STANDING INSTRUCTIONS TO THE PROJECT OPERATOR FOR WATER CONTROL

**BLUE DIAMOND DETENTION BASIN
BLUE DIAMOND WASH
CLARK COUNTY, NEVADA**

December 2002

BLUE DIAMOND DETENTION BASIN LAS VEGAS, NEVADA
PROBABLE MAXIMUM FLOOD ROUTING Basin Hyetograph and Inflow, Outflow and Stage Hydrographs
U. S. ARMY CORPS OF ENGINEERS LOS ANGELES DISTRICT

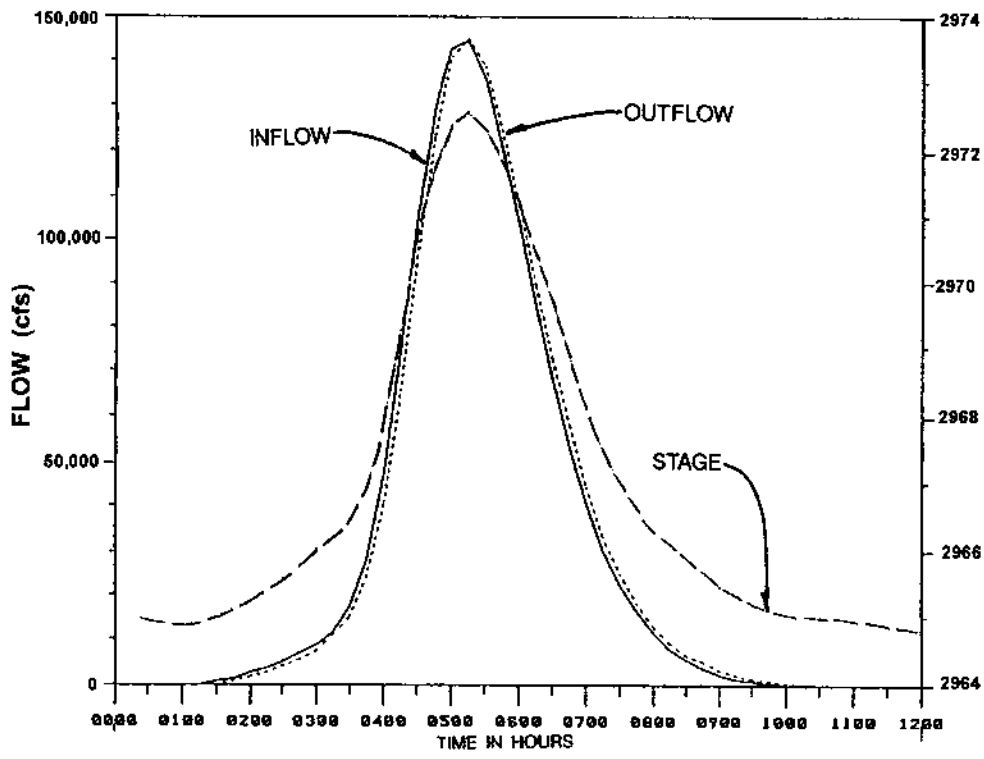
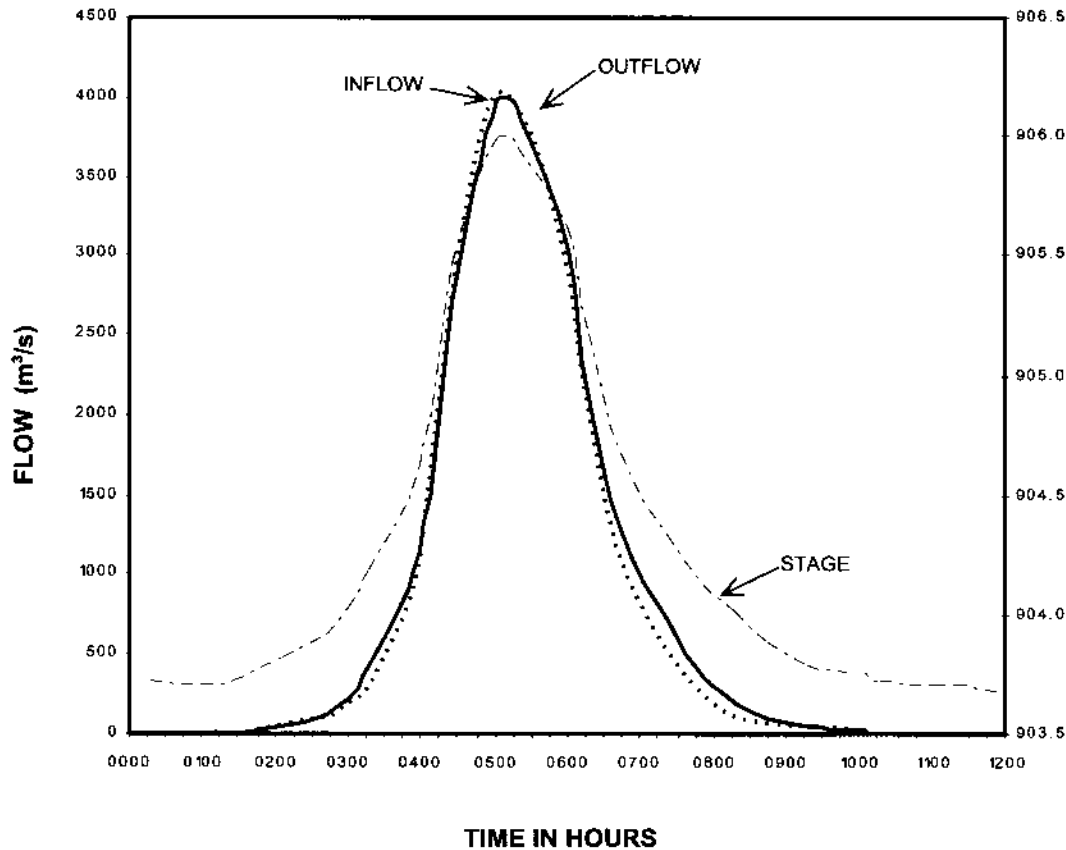
13. Plates 23 and 23a. On Plate 23, correct drainage area, maximum storage, maximum stage, and maximum outflow to match Pertinent Data Table and Plate 18. On Plate 23a. Correct maximum storage and maximum stage to match Pertinent Data Table and Plate 18.

13. Plates 23 and 23a. On Plate 23, correct drainage area, maximum storage, maximum stage, and maximum outflow to match Pertinent Data Table and Plate 18. On Plate 23a, correct maximum storage and maximum stage to match Pertinent Data Table and Plate 18.

RESERVOIR DESIGN
 FLOOD ROUTING
 Basin Hyetograph and Inflow,
 Outflow and Stage Hydrographs

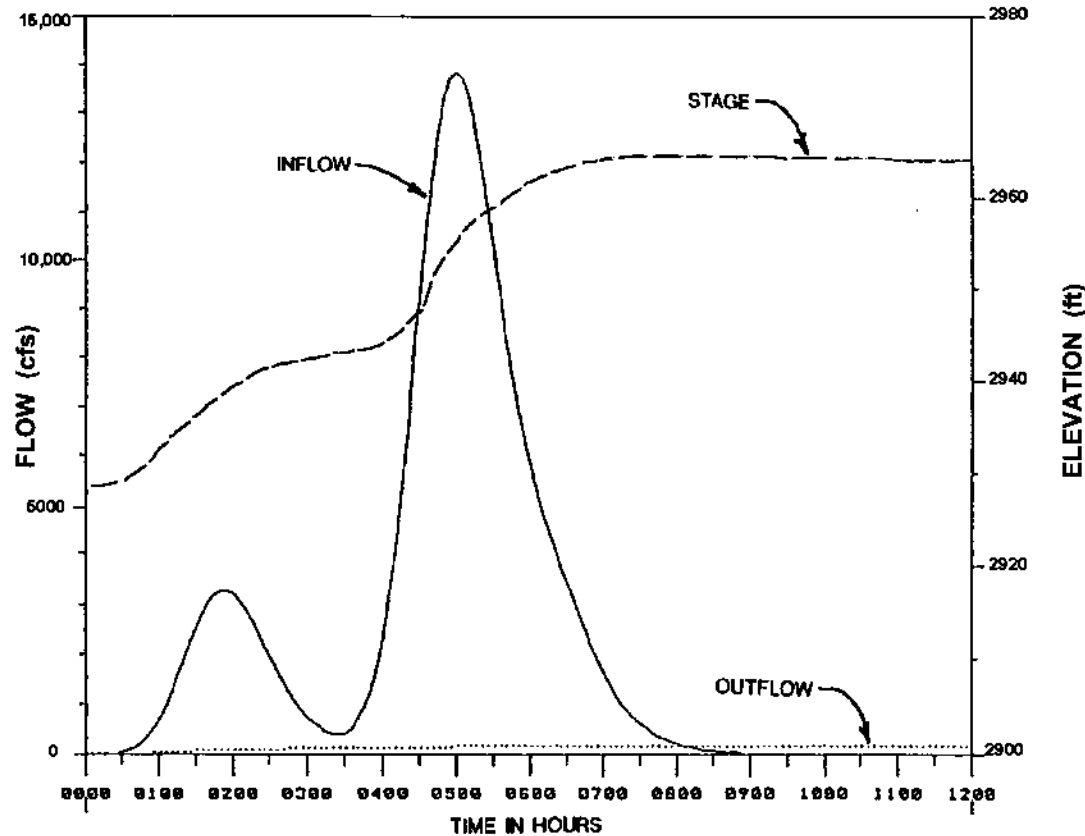
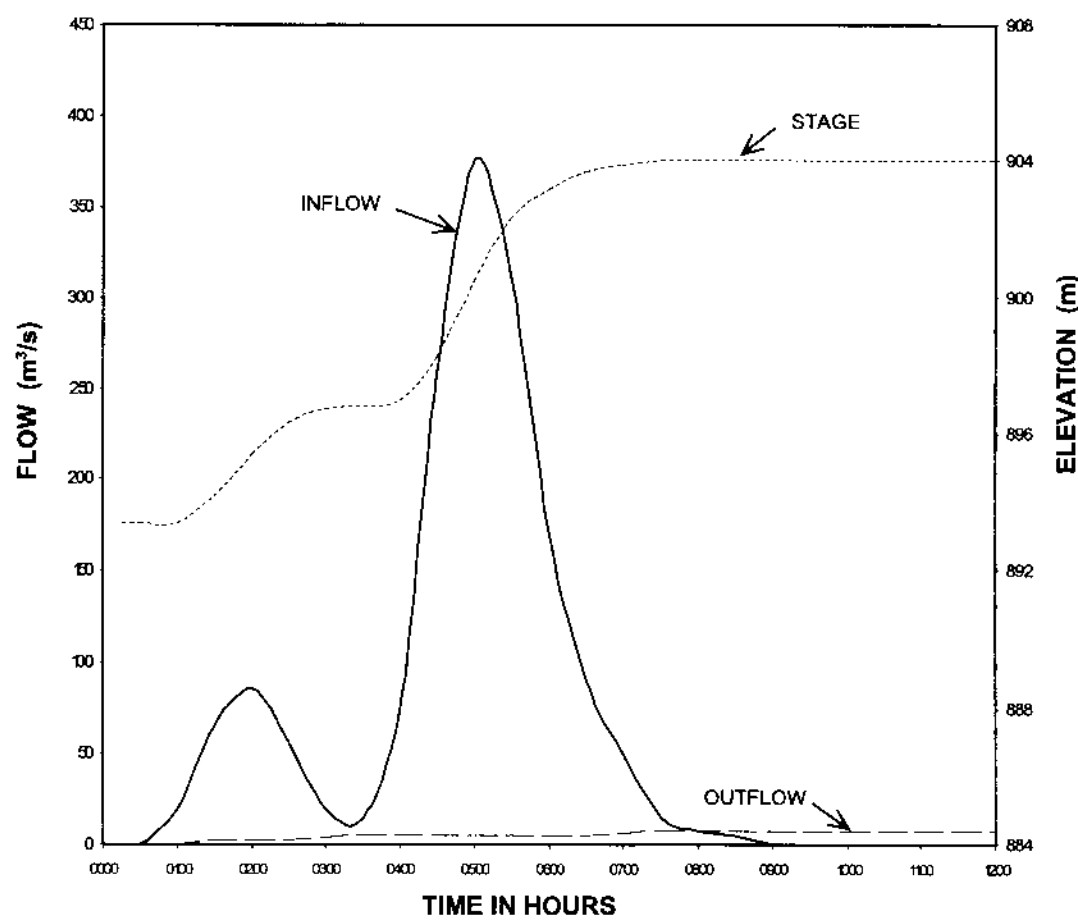
14. Plates 24 and 24a. On Plate 24, correct drainage area, maximum inflow, maximum storage, inflow volume, and maximum stage to match Pertinent Data Table and Plate 18. On Plate 24a, correct maximum storage, inflow volume, and maximum stage to match Pertinent Data Table and Plate 18.

14. Plates 24 and 24a. On Plate 24, correct drainage area, maximum inflow, maximum storage, inflow volume, and maximum stage to match Pertinent Data Table and Plate 18. On Plate 24a, correct maximum storage, inflow volume, and maximum stage to match Pertinent Data Table and Plate 18.
15. Plate 25. Remove stream gage note from figure.
